GEOSHIELD Verification Report

SURVEY AREA: Upper Raft Slab Termination

From: Cameron Vauvelle-Don
To: [Laing O'Rourke](#)
Cc: [Stephenson, Robert](#); [Scott, Michael T](#); [Thomas, Oliver](#); [Abraham Moss Library](#); and [Leisure Centre](#)
Subject: RE: Abraham Moss - Proposed Gas Termination detail
Date: 17 February 2022 14:12:40
Attachments: [mossdetail.dwg](#)

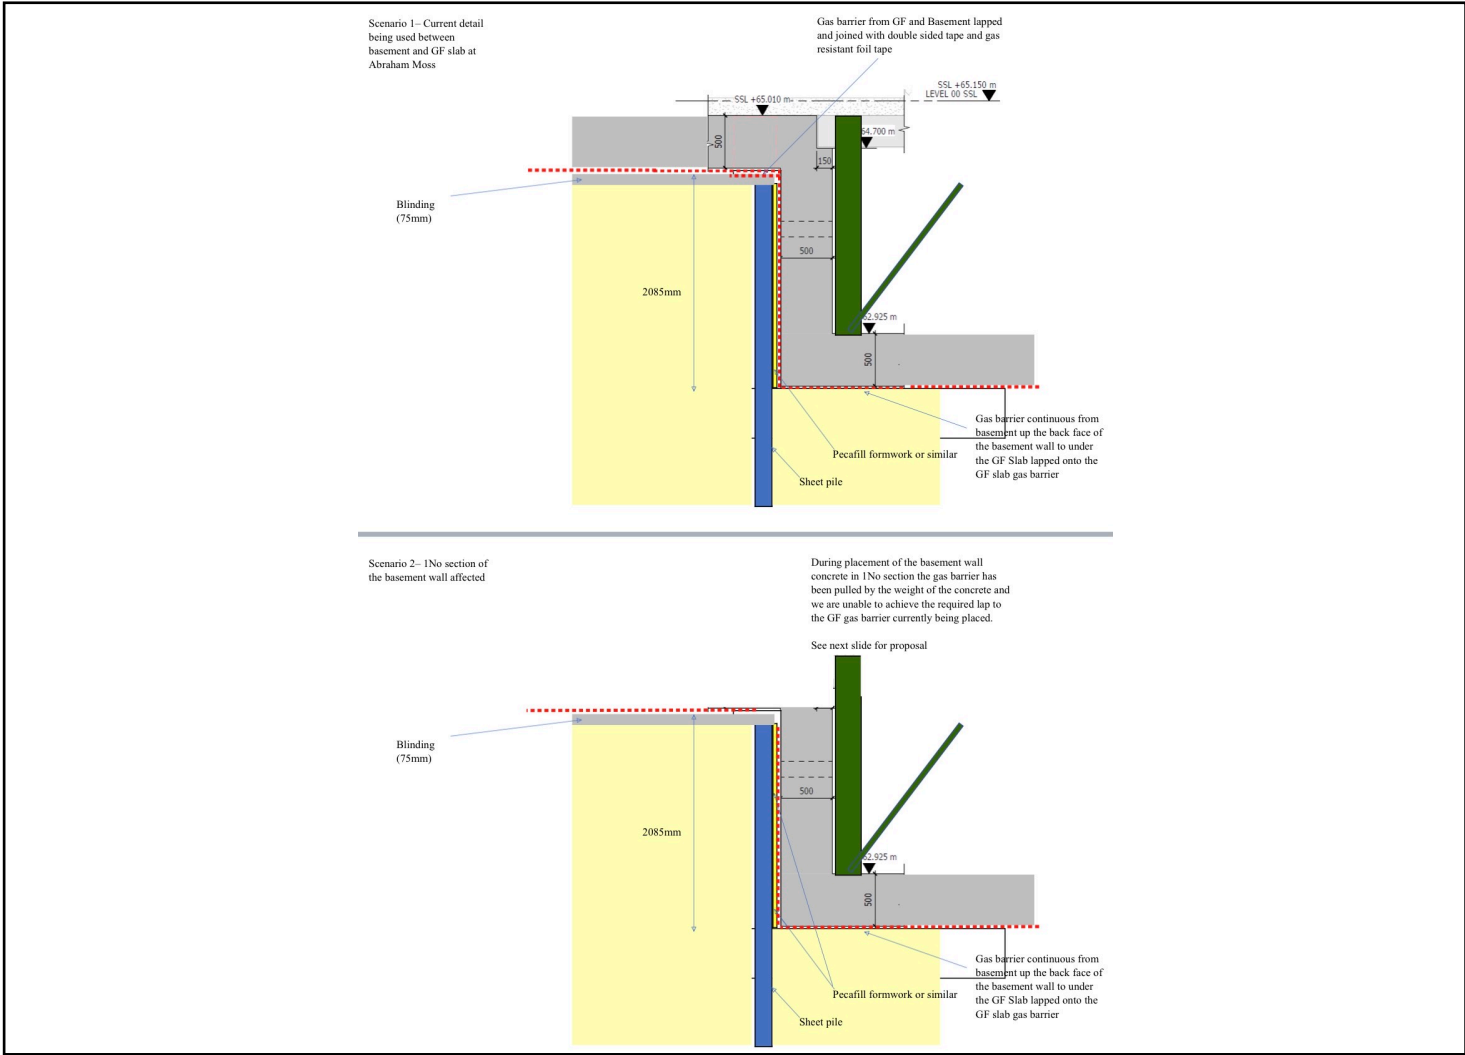
RESTRICTIONS AND LIMITATIONS: During the site visit an issue was found with the termination of the Upper Raft Slab and the Visqueen Standard Gas Barrier applied vertically from the basement slab. The drawing below shows the original design detail. However during the pour the tail which was due to be terminated to has been covered

Phil,
Many thanks for the email.
I have just looked at your proposal and Visqueen is happy that the solution will give us the best possible method of sealing from the Gas Barrier to the retaining wall and then onto the underside of the upper slab.
It is a workable solution.
If you need anything else then please let me know.
Kind regards,
Cameron
Cameron Vauvelle-Don (CS9W)
Technical Support Manager
Phone: +44 (0) 333 202 6800
Mobile: +44 (0) 7471 49288
Email: cvaudeveldon@visqueen.com
